**RE: Beer Garden at Stapleton
Site Plan and Conditional Uses**
Response to 2nd Review Comments

Following are responses to comments issued by the City of Aurora on October 21, 2019 for the proposed Beer Garden at Stapleton (the "Project") located at 2323 Dayton Street.

BEER GARDEN @ STAPLETON
2323 DAYTON,
AURORA, COLORADO

SITE PLAN AND CONDITIONAL USES

SHEET TITLE:
LANDSCAPE PLAN

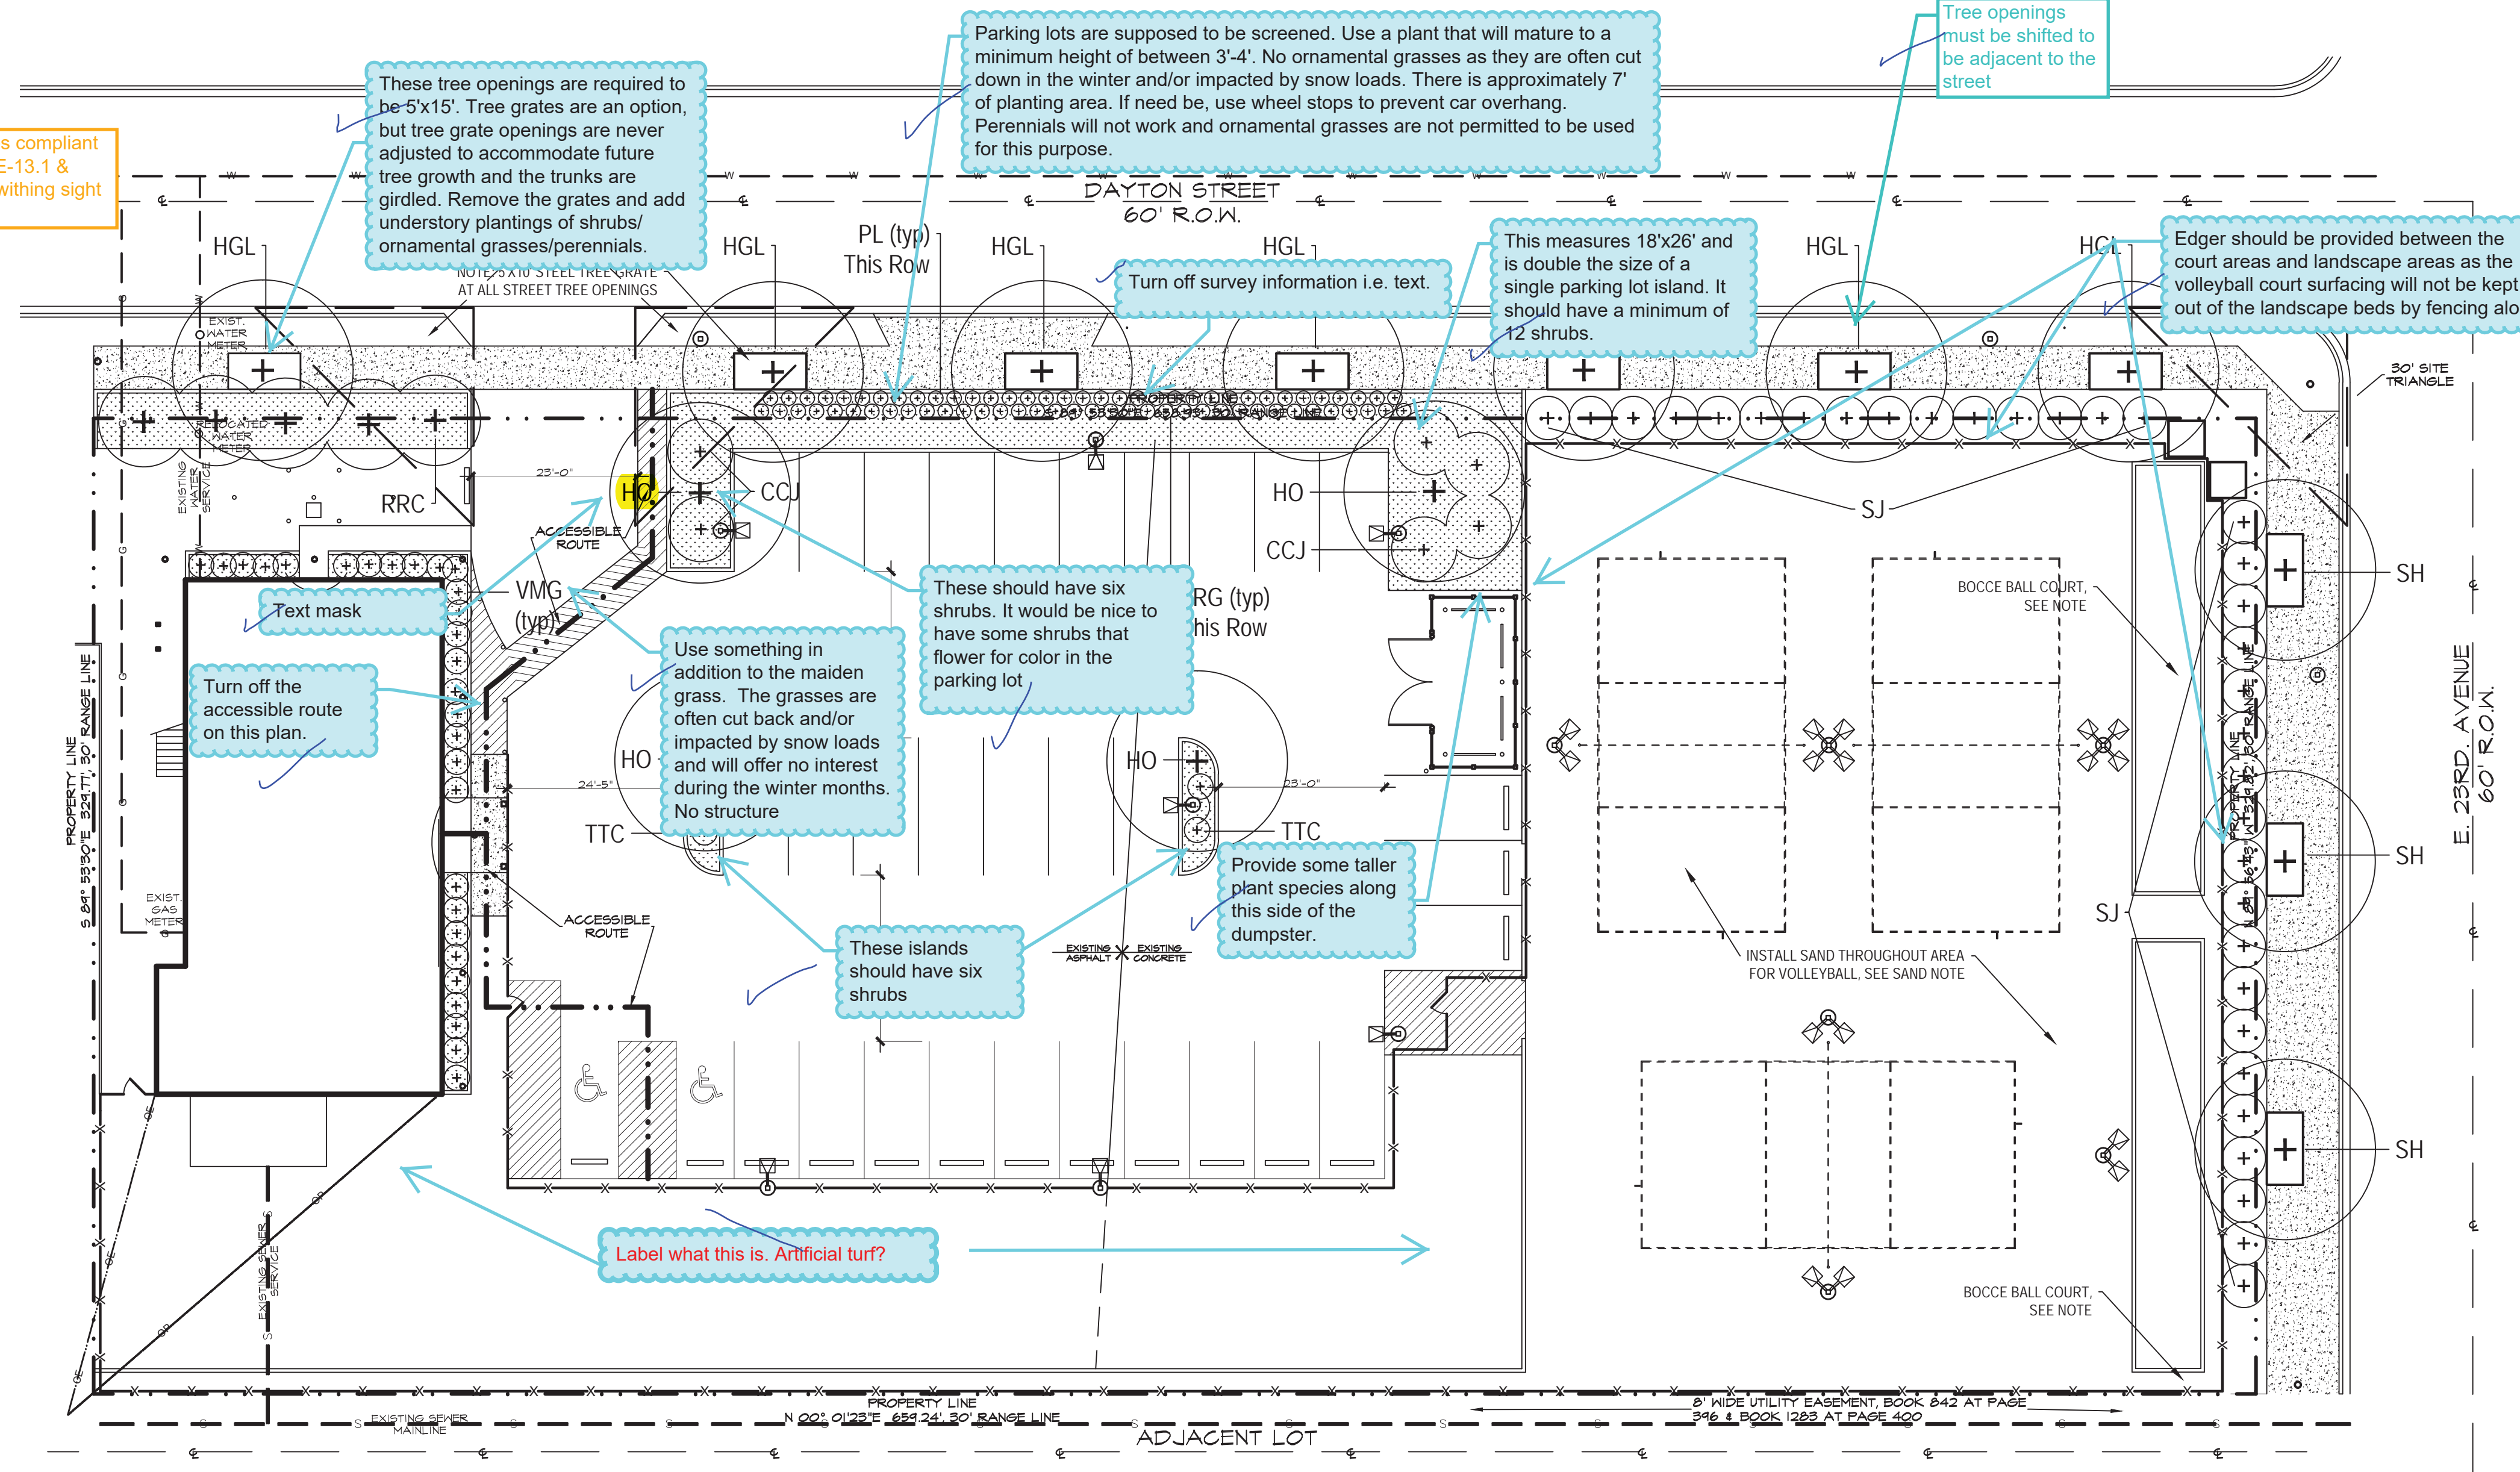
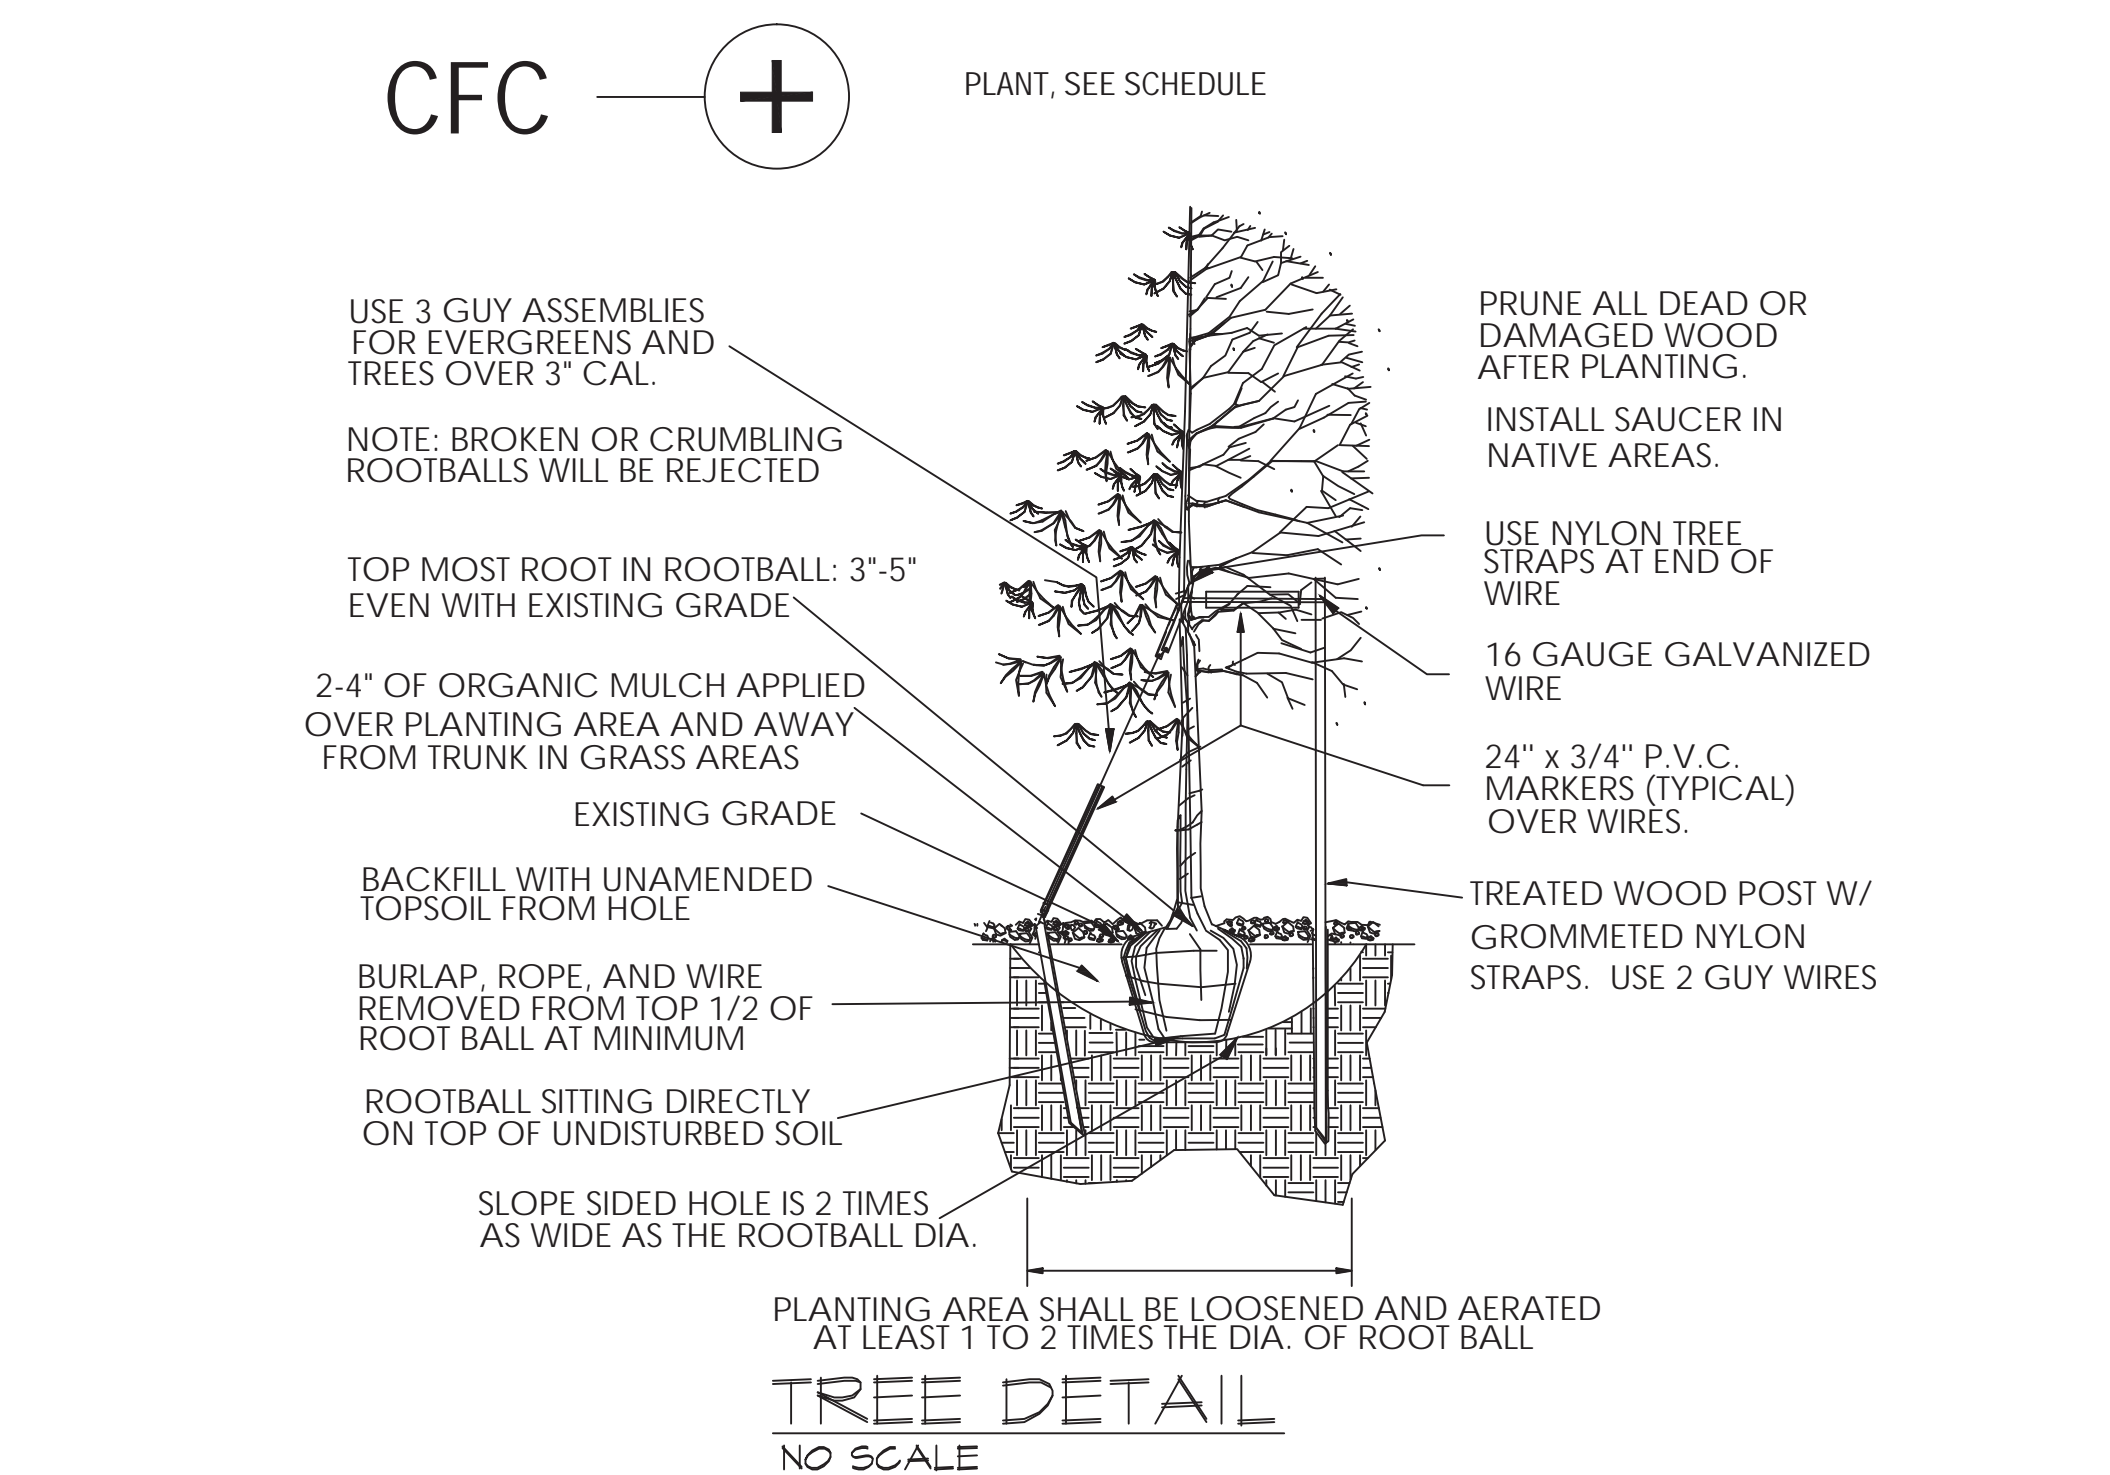
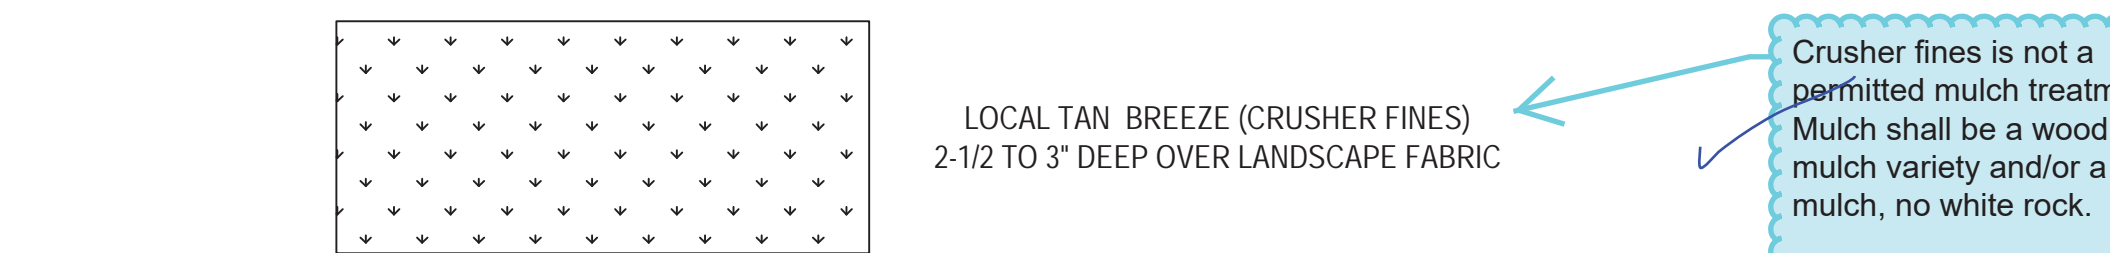
Include plant symbology in the legend.

Add sight triangles compliant with COA STD TE-13.1 & review plantings withing sight triangles.

Add the City's Sight triangle note: 'All proposed landscaping within the sight triangle shall be in compliance with COA Roadway Specifications, Section 4.04.2.10'

Please include a site data table like the following

Add "Not for Construction" to the landscape plan

Include the proposed grading, grayed back.
